STAFF RECOMMENDATION
300 Broadway
September 21, 2016

Application: New construction—addition
District: Broadway Historic Preservation Zoning Overlay
Council District: 19
Map and Parcel Number: 09306308200
Applicant: Janie Wright, Tuck Hinton Architects
Project Lead: Robin Zeigler, robin.zeigler@nashville.gov

<p>Description of Project: Application to construct a rooftop addition.</p> <p>Recommendation Summary: Staff recommends approval of the addition with the conditions that:</p> <ol style="list-style-type: none">1. The awning over the bar is removed, allowing the bar itself to remain in the step-back area;2. The four foot (4') canopy/coping overhang be reduced to no more than two feet (2');3. Applicant submit detail drawings showing the design of the addition; and4. Staff provide final review of window, doors and metal color. <p>With these conditions, Staff finds that the application will meet Sections III. H for rooftop additions in the Broadway Historic Preservation Zoning Overlay.</p> <p>Staff further recommends that the applicant return to the Commission or Staff with a signage application, lighting and any other facade alterations planned.</p>	<p>Attachments</p> <p>A: Photog

16' 8' 0 16'
BROADWAY SECTION

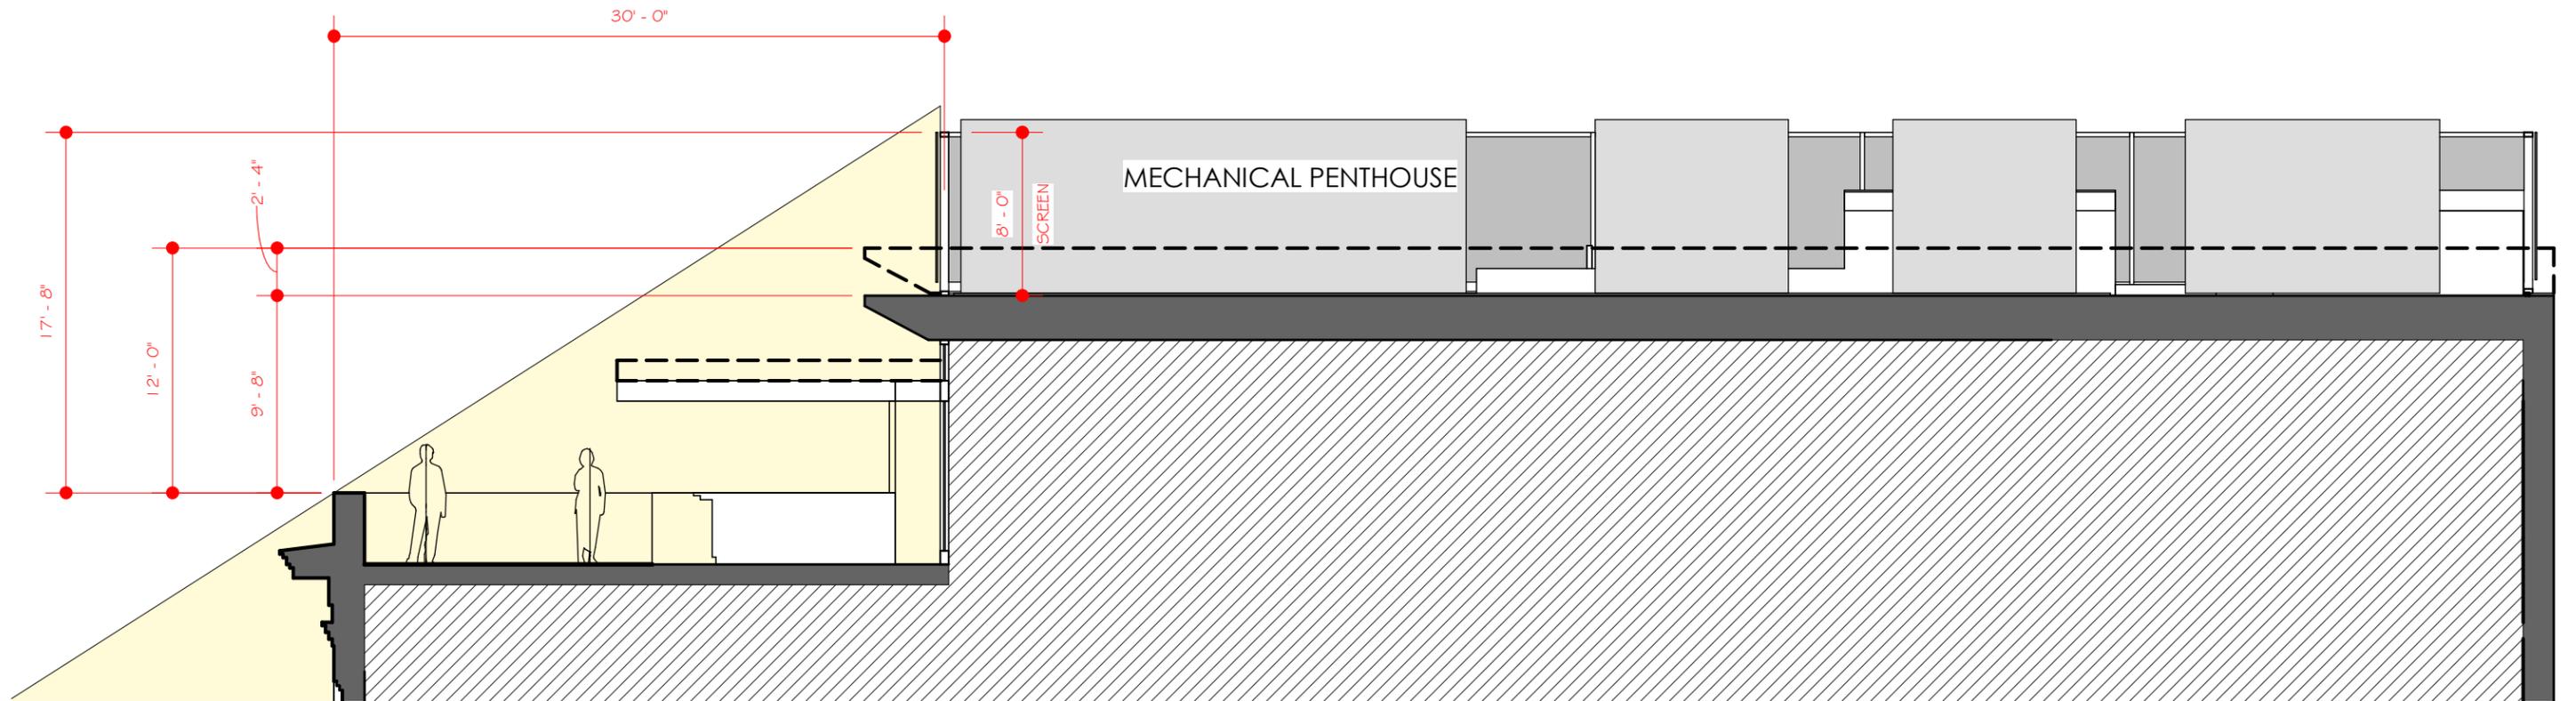
1. A canopy/coping around the addition extends into the step-back area by approximately four feet (4’).
2. A covered bar that is eight feet (8’) wide protrudes sixteen (16’) into the required front step-back area.
3. On the Third Avenue North side is a stairwell that protrudes into the step-back area by thirteen feet (13’). The stairwell is four feet (4’) tall above the parapet wall and seven feet (7’) wide.

Staff recommends that the bar awning be removed; however, the bar itself may remain. In 2012 a similar request to cover a rooftop bar located within the step-back area was denied. No other such requests have been approved.

Staff recommends that the coping surrounding the addition protrude no more than two feet (2') into the step-backed area. The Commission should be aware that this approval could set a precedent as no other such requests have been approved.

1. The awning over the bar is removed, allowing the bar itself to remain in the step-back area;
2. The four foot (4') canopy/coping overhang be reduced to be no more than two feet (2');
3. Applicant submit detail drawings showing the design of the addition; and
4. Staff provide final review of window, doors and metal color.

ENLARGED BROADWAY SECTION

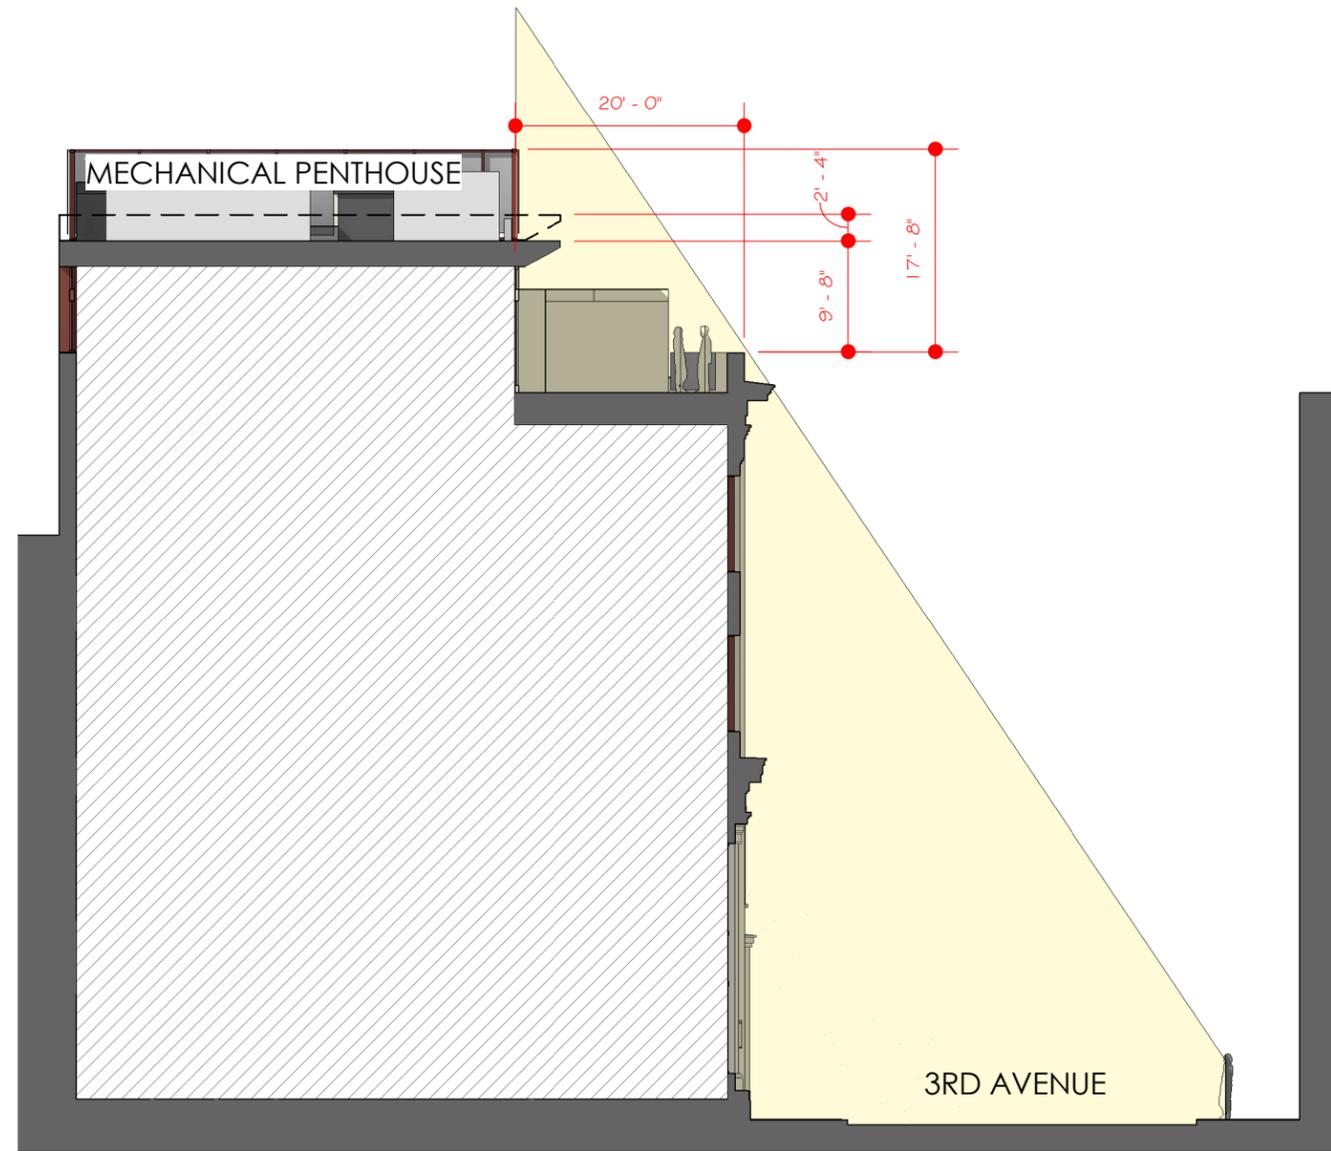
Height: The design guidelines require that a rooftop addition be no taller than fifteen feet (15') above the front parapet wall; however, the proposal is for seventeen feet (17') above the parapet wall, including the mechanical screen. Additional height has not been approved in the past, in like situations. Staff recommends disapproval since the proposal does not meet the design guidelines and similar requests have not been approved.
